Product : Color monitor
Model : CFX1577 Model
Buyer : All subsidiaries

Bulletin No. 98-MON-E0001
Bulletin Date 1998.1.20
ECN Date : 1998.1.19

SUBJECT : CFX-1577, Countermeasure for centering focus problem

Before schematic Diagram

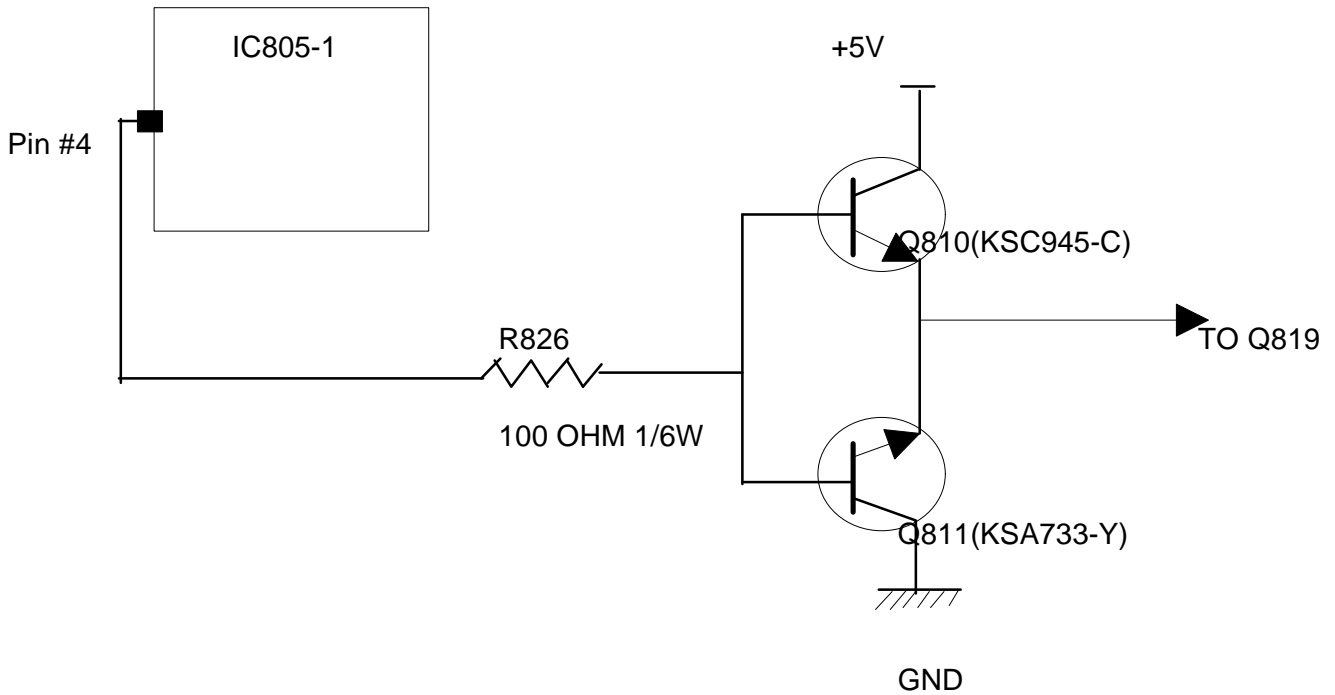
Background : Sometime screen flickering or center focus problem at field.
 (Symptom)

Cause : Internal core of L801(Focus Trans Coil)is saturated due to over current of suspend mode.

Solution : Change focus schematic diagram

| Location No. | OLD (before) Parts | | NEW (changed) Parts | | * |
|--------------|--------------------|-------------|---------------------|--------------------|-----|
| None | | | 2202-000394 | C-MYLAR 102J/100V | E |
| None | | | 0401-000005 | DIODE-SIG,1N4148DO | E |
